RE: Motiva Enterprises LLC CAM Plan

COMPLIANCE ASSURANCE MONITORING (CAM) PLAN

Motiva Enterprises LLC – Port Tampa Terminal
FDEP Facility ID 0570197

Re: Periodic Monitoring Plan and CAM Plan

Figure 1
Loading Rack Block Flow Diagram

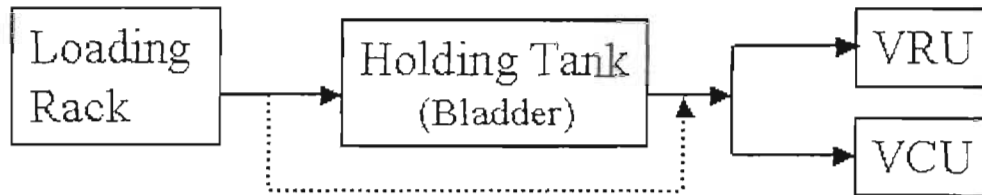
all good
